**Campaign code.**L62X-A.04.18**Campaign description.**Wheel badge upgrade**Model.**Huracan Performante Coupè and Spyder**Model year.**2018**Special or Limited Versions.**Only with central single nut with standard wheel badge;
(no carbon fibre).**Markets.**All.**VIN identification**From JLA06599 to JLA09015**Warning:** before starting with the repair, log to the Warranty portal and check through VIN Info:

As a result of the continuous monitoring of the product, Automobili Lamborghini Spa introduced a new O-rings of increased hardness and a hole on the hubcaps to prevent accidental loss of the hubcaps.

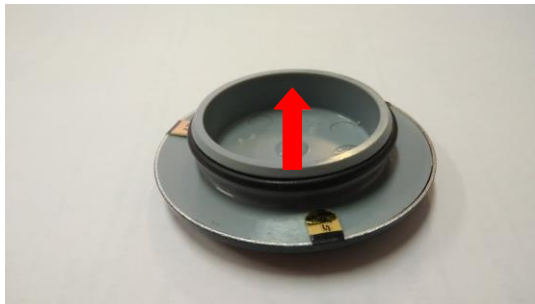
2. Remove the old O-ring, pulling in the direction of the arrow.

3. New configuration (wheel badge without O-ring).

**C. Drilling of the wheel badge.**

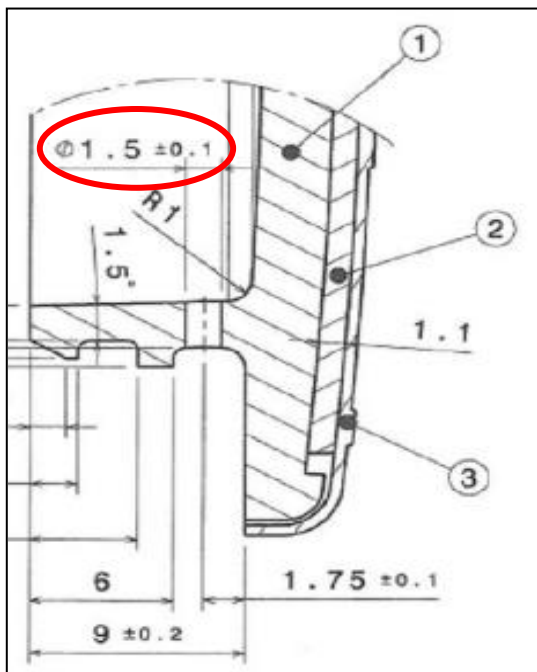
4. Follow the technical drawing specifications to make the 2 holes ($\varnothing 1,5$ mm) in the correct position of the badge (Space A in the figure).

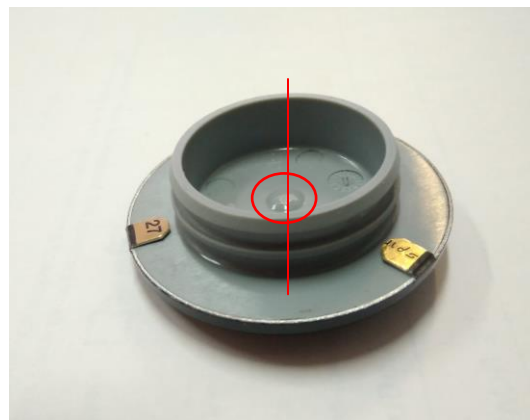
5. To find the correct position of the holes Automobili Lamborghini recommend using the circled point in the image as a reference (in order to obtain two alligned holes). Using like a reference the circled point in the figure and mark the 2 points where you will need to drill the holes.

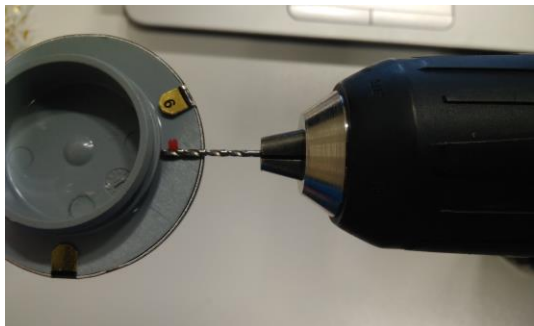
The points must be marked in the space A (see image below).

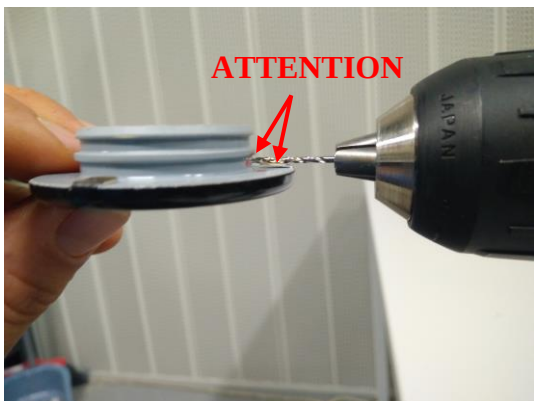
To avoid damaging of the badge, be careful not to touch the points shown in the following figure during the drilling operation.

D. Installation of the new O-ring in the wheel badge.

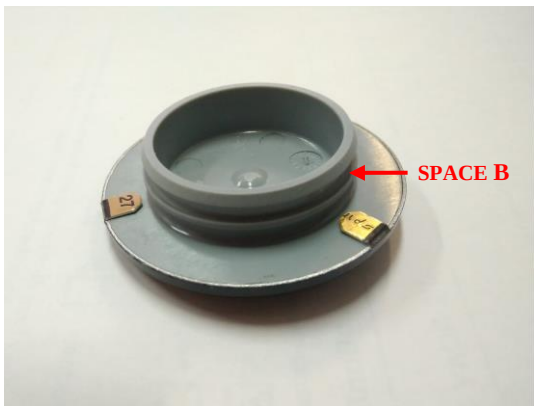
7. Install the new O-ring (part number 470698009) in the space B (see the figure), pushing in the direction of the arrow.
